Determination 2011/085

Regarding the issue of a notice to fix in respect to a channel drain to a house at 2/35A Wheturangi Road, Greenlane, Auckland

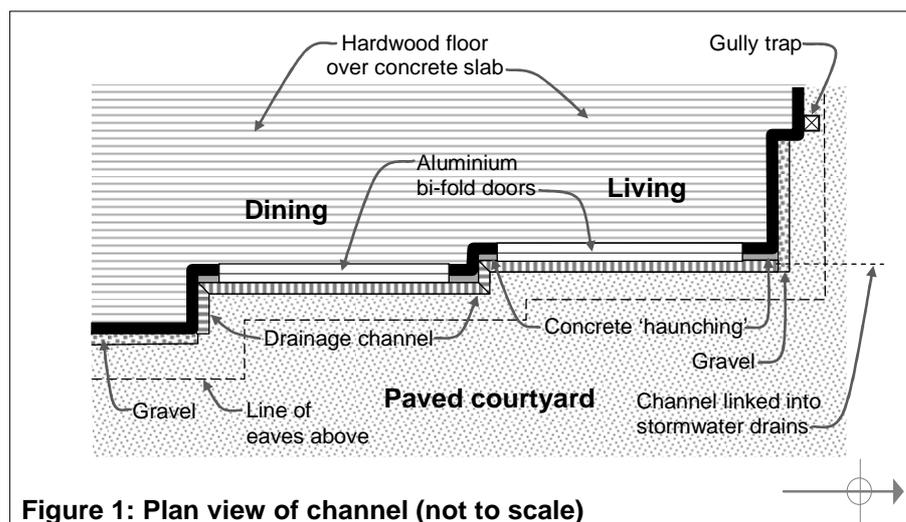
- 2.1 The subject drainage channel is to part of the rear elevation of a two-storey house situated on a level building platform in a low to medium wind zone for the purposes of NZS 3604⁴.
- 2.2 The construction of the house is generally conventional light timber frame, with a concrete slab and foundations, timber weatherboards over a cavity, aluminium joinery with timber facings and sills, and profiled metal hipped roofing with eaves of more than 500mm overall.
- 2.3 Lean-to roofs extend over ground floor walls, including above the drainage channel, which extends along part of the east (rear) elevation as shown in the plan view sketch in Figure 1.

5.2.1 The expert noted that the 130mm wide and 120mm deep drain is 7.4m long and drains to the northeast corner of the house, where it connects to the stormwater system. The paved area adjacent to the channel drain is about 20m², with a maximum slope of 1:100 away from the drain. The expert described the channel junction; and I have incorporated his comments within the sketches in Figure 1 and Figure 2 (see paragraphs 2.3 and 2.4).

- 2.4 Based on the limited information available, an indicative sketch of the wall to paving junction at the channel drain is provided in Figure 2:

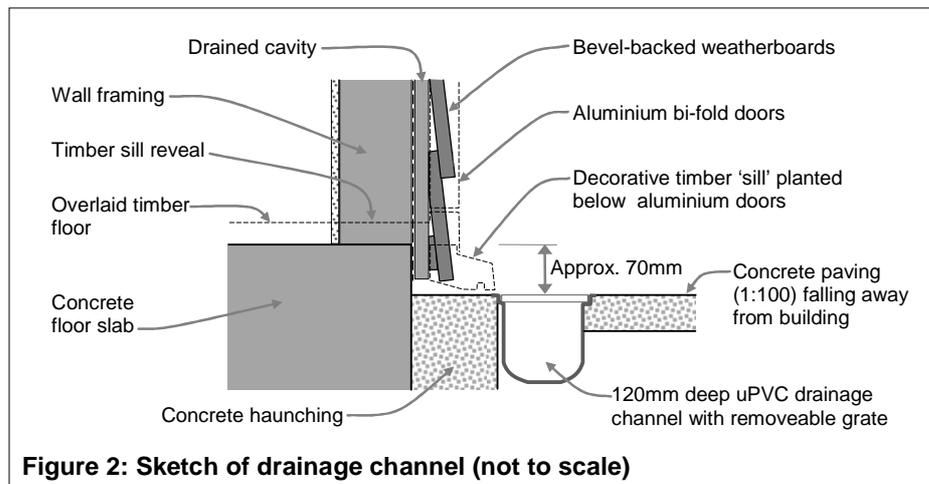
5.2.2 The expert noted that water run-off from the large doors flows over the planted timber sill onto the edge of the channel drain, the bottom of which is about 190mm below the bottom plate level. However, the top of the concrete haunching to the foundations is exposed at small sections of weatherboards adjacent to the doors.

- concrete haunching adjacent to weatherboards provides an exposed ledge about 70mm below the bottom plate level, which prevents aggregated clearances from being measured to the bottom of the channel
- there is only about 20mm clearance below the bottom painted edge of the weatherboards to the concrete ledge, which makes repainting 'next to impossible' and the edge subject to deterioration unless treated to H3.2
- there is only about 2 to 3mm clearance below the bottom edge of the timber sill below the slicing doors to the concrete haunching, which makes the timber effectively in contact with paving and subject to deterioration unless treated to H4.

6.3.3 A method of providing adequate clearance to the bottom of the weatherboards and door way sills to the bottom of the subject walls is a matter for the applicant and his designer to propose. The presence of the concrete haunching prevents adequate clearances for draining and drying to the bottom of the cladding and joinery. I suggest that this may require removal of the haunching and modifying channel drain to extend it back to the main slab. An experienced designer will be able to investigate the existing construction and consider how this could be affected.
